# HARBOUR FRONT PROPERTIES PRIVATE LIMITED

**Sub:** Submission of Half yearly compliance report for period of April 2024 – September 2024

**Ref:** EC vide no EC23B038MH148459 dated 26.05.2023; file no SIA/MH/INFRA2/416970/2023

M/s Harbour Front Properties Private Limited has obtained Environmental Clearance vide no EC23B038MH148459 dated 26.05.2023 having file no SIA/MH/INFRA2/416970/2023 for Proposed redevelopment project located at CS no 932 of worli division, plot no 73(pt)-74, B G Kher road, Worli, G/south, Mumbai.

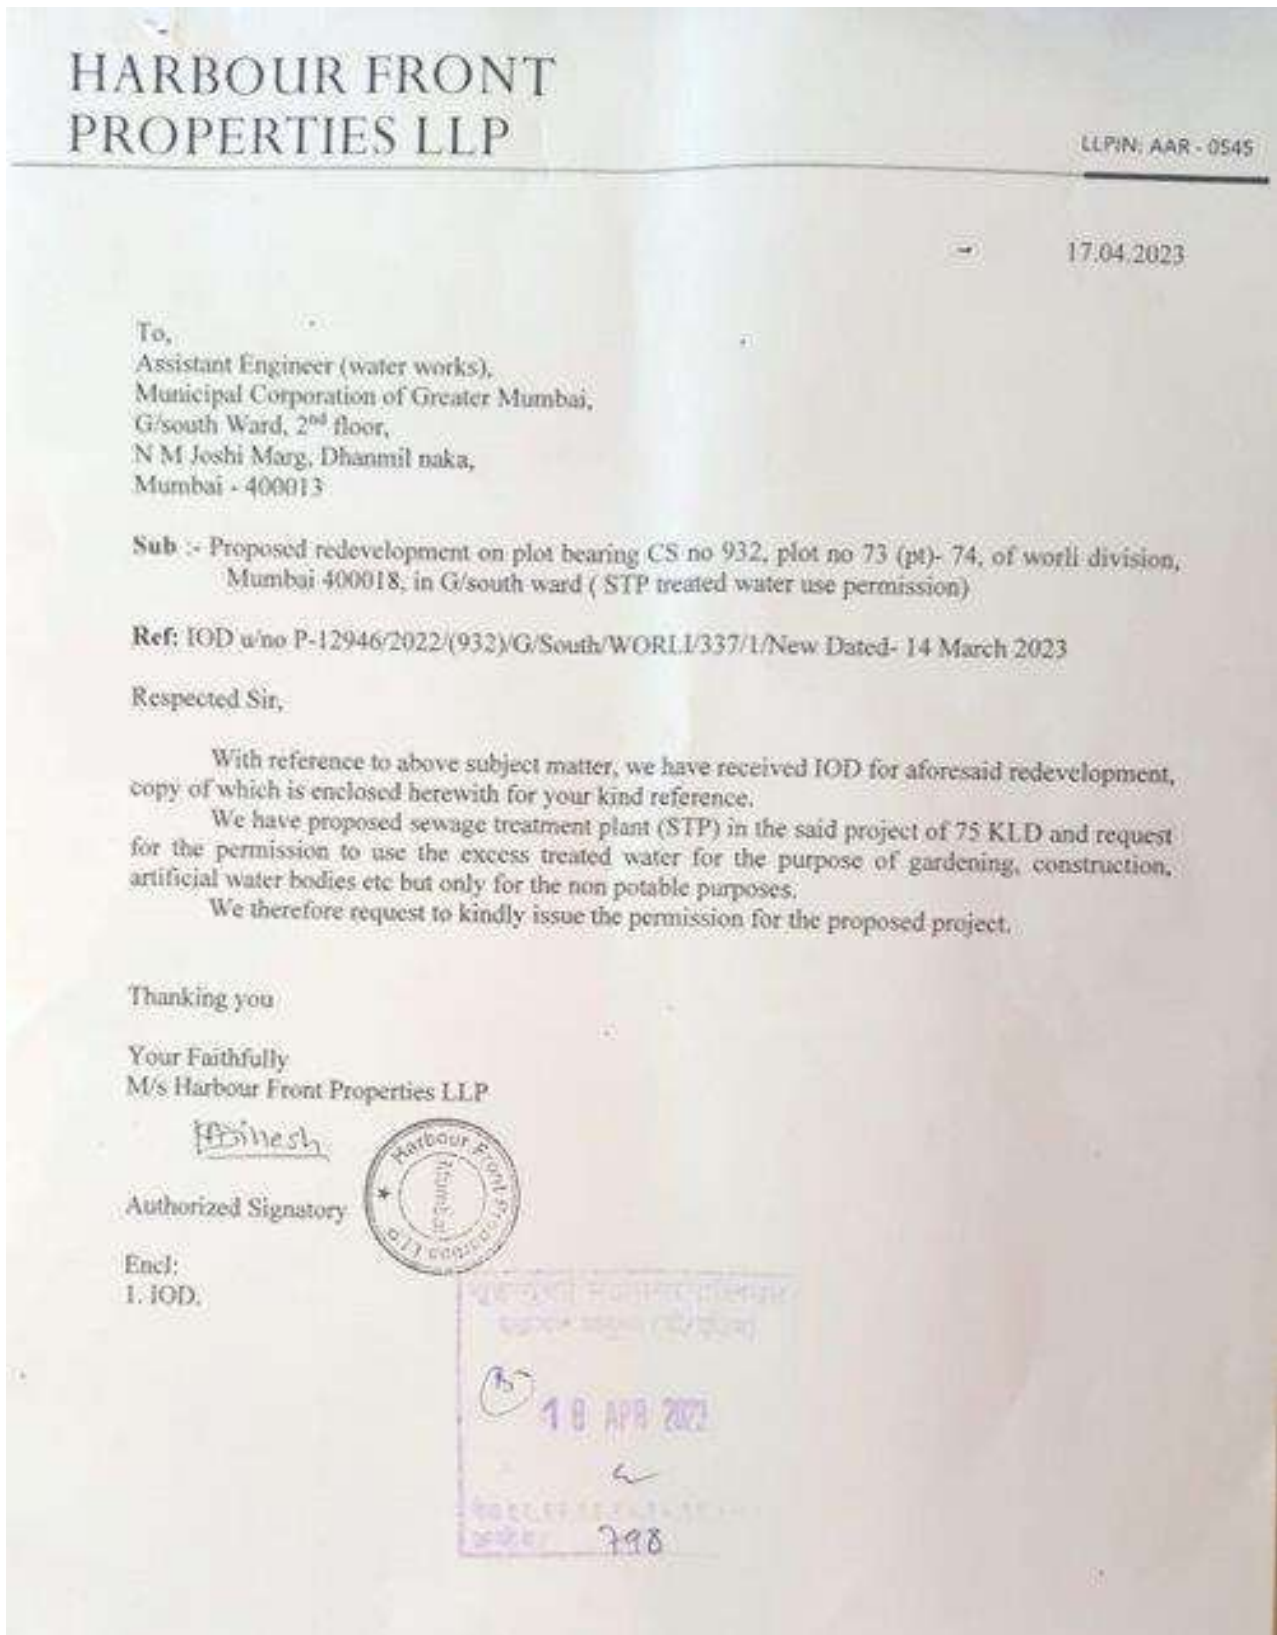
**SEAC Condition 3:** PP to submit revised water balance Chart by Changing/removing the use of excess treated water for car washing. PP to submit NOC/undertaking from MCGM regarding use of excess treated water for gardening.

**Reply:** The revised water balance chart by changing /removing the use of excess treated water for car washing is as follows :

NOC /undertaking from MCGM regarding use of excess treated water for gardening: Request letter submitted to MCGM.

**LOCATION OF UG TANKS: BASEMENT 1**

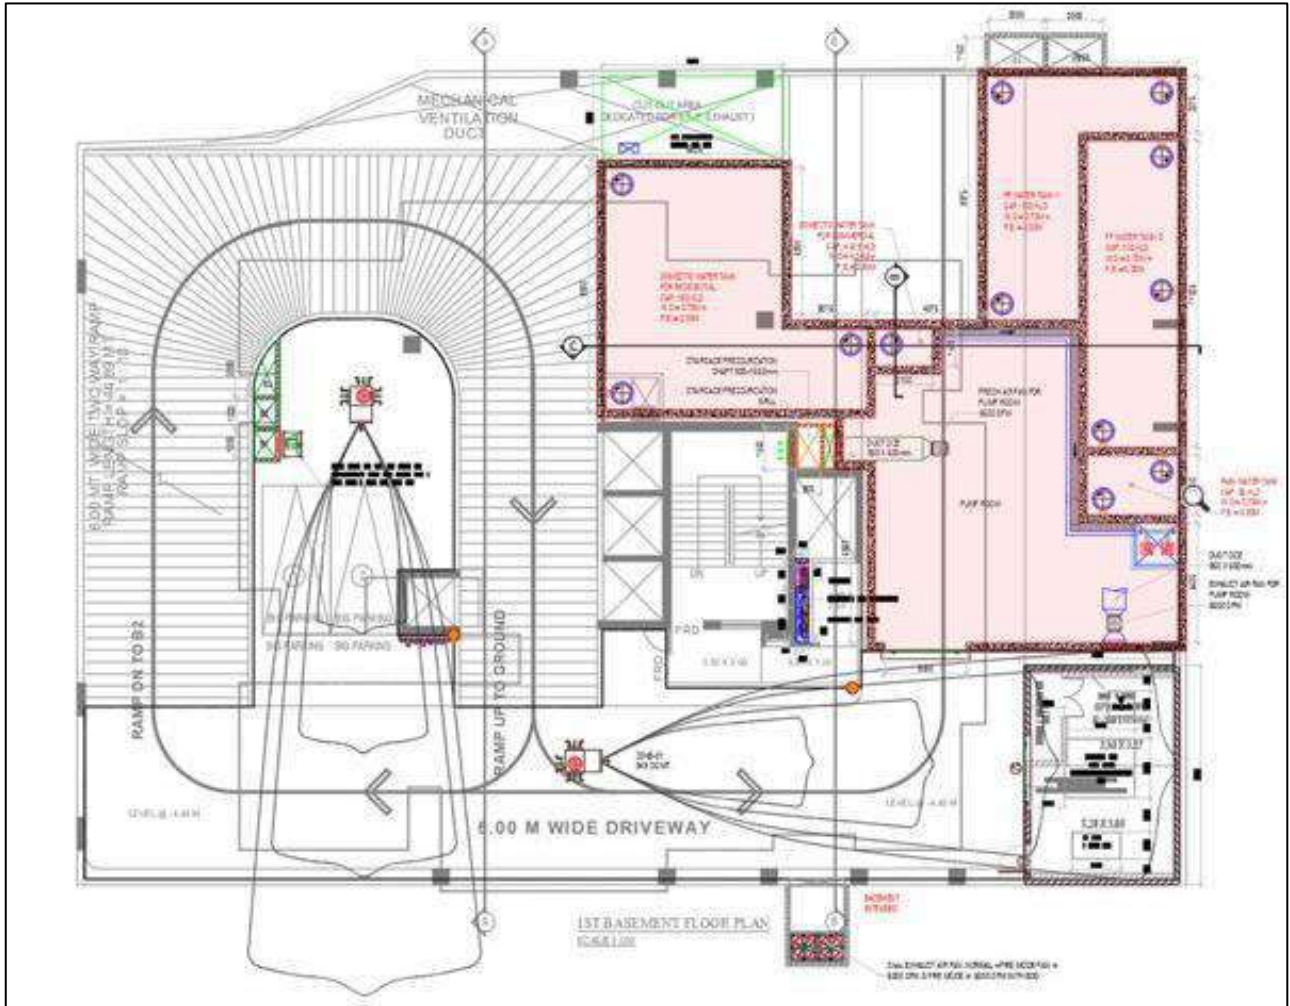
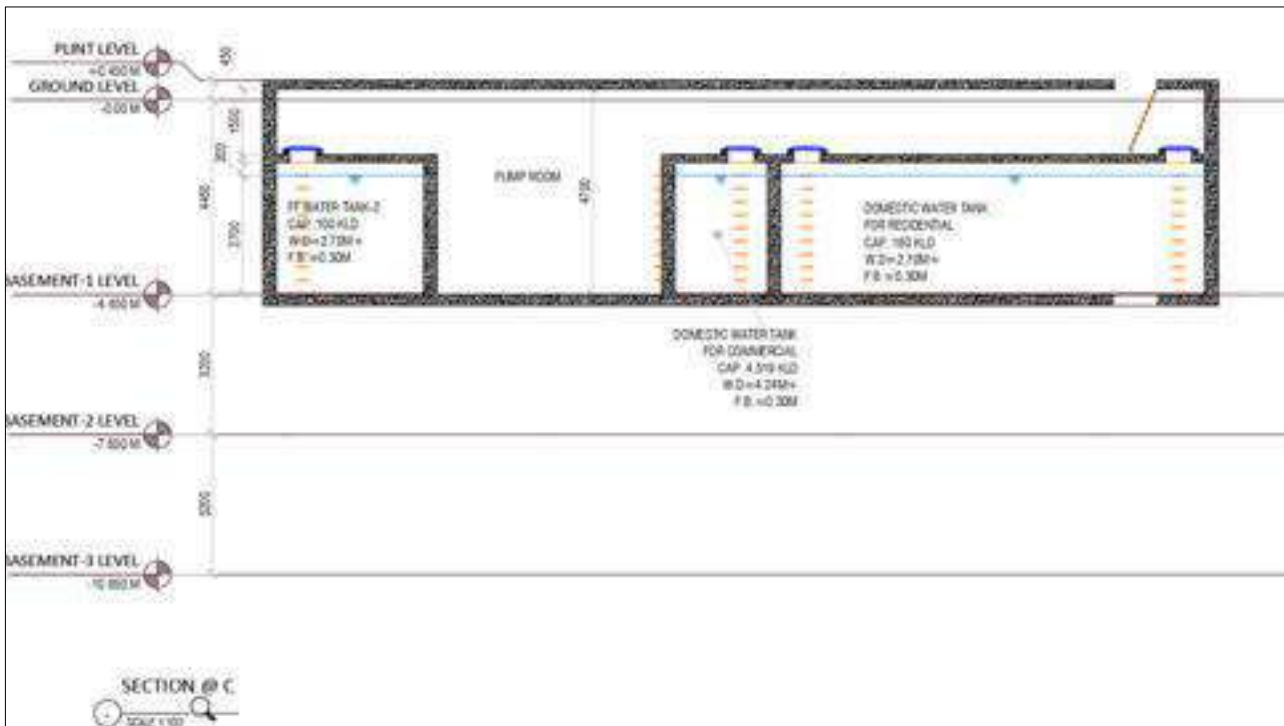
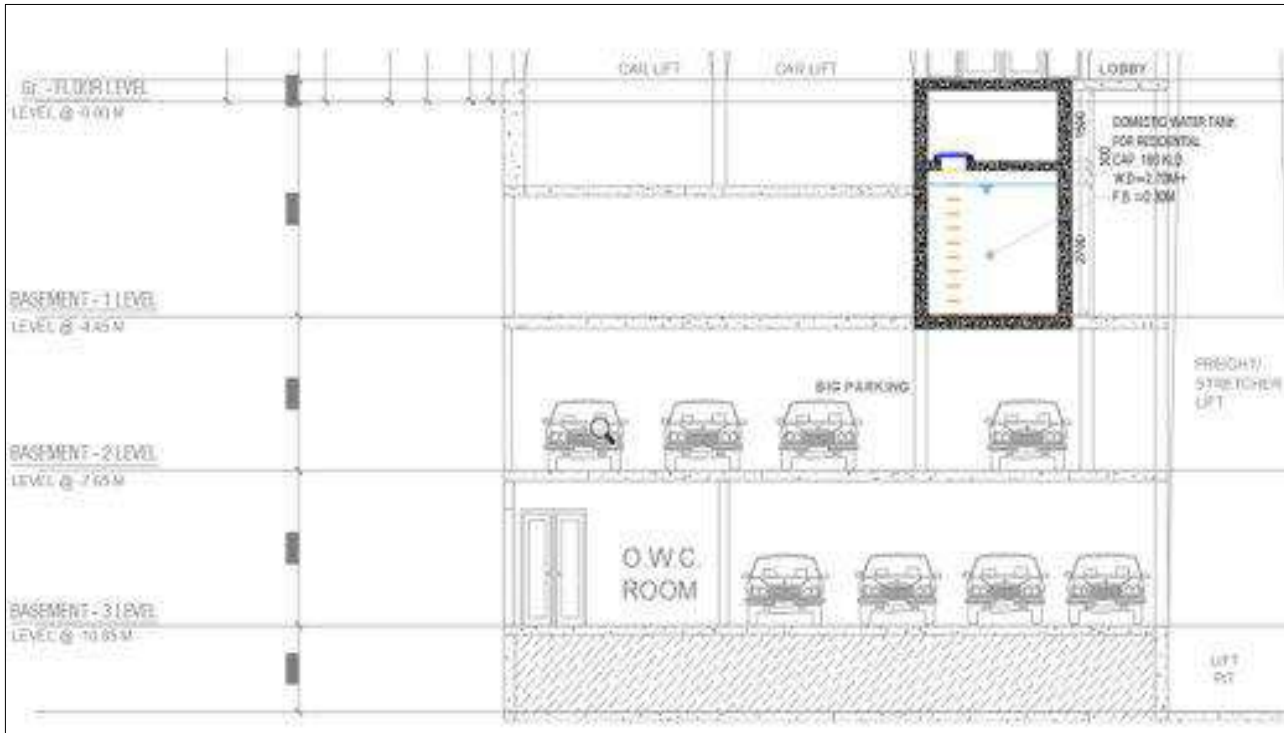
**SEAC Condition 7:** PP to relocate UGT to 1<sup>st</sup> basement such that top of the UGT is flush to the ground level as mentioned in CFO NOC & submit revised layout of UGTs with cross section.

**Compliance:** As directed, we have relocated the UGT to 1st basement such that top of the UGT can be accessed from the ground level.

Figure 2.2. CFD slice in the Z axis at 28th floor with maximum wind velocity of 12m/s.

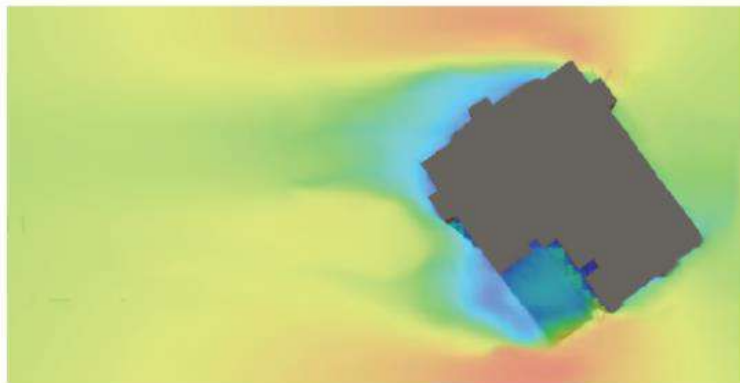
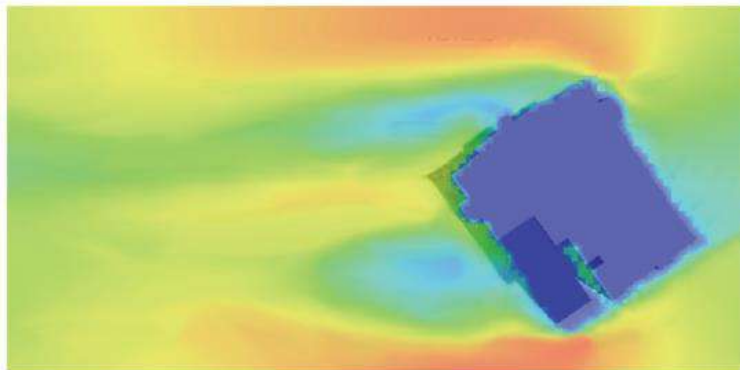
**Compliance point 5** - Submit revised wind analysis for proposed height & accordingly submit revise mitigation measures.

**Reply:** The revised wind analysis for proposed height and revise mitigation measures is as follows:

- Based on the Beaufort scale data, the wind speed observed in the analysis falls under the Strong Breeze category, with a maximum wind speed of 12m/s.
- This wind speed is not expected to have any significant impact on the building's structural integrity.
- Structural consultant has designed the building with due consideration to IS code -875-2015, with consideration of wind speed of 44 Mts/sec ( 50 years of return period )for the said structure.

**RG AREA DETAILS- LANDSCAPE PLAN | GROUND FLOOR**

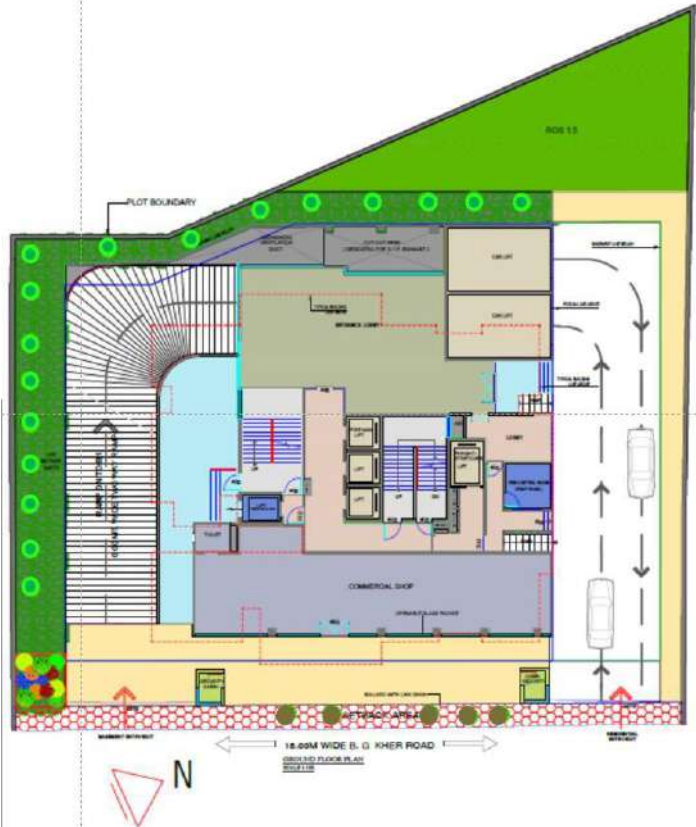
**Compliance Point:** PP to Submit architect certificate mentioning % of paved, Non-Paved & podium RG provided is as per provision of DCPR 2034 provisions. PP to convert 5% of proposed RG area into Miyawaki Plantation & include the cost of same in EMP, PP to submit revised tree list with nos. of trees Proposed with species to be planted in Miyawaki Plantation.

**Reply:** The revised architect certificate mentioning % of paved, Non-Paved & podium RG provided is as per provision of DCPR 2034 provisions:

RG AREA STATEMENT	
Net Plot Area	1578.73sq mts
15% RG	236.81sq mts
Proposed RG	249.09sq mts
RG on Ground	163.28sq mts
8th Podium Floor	85.81sq mts
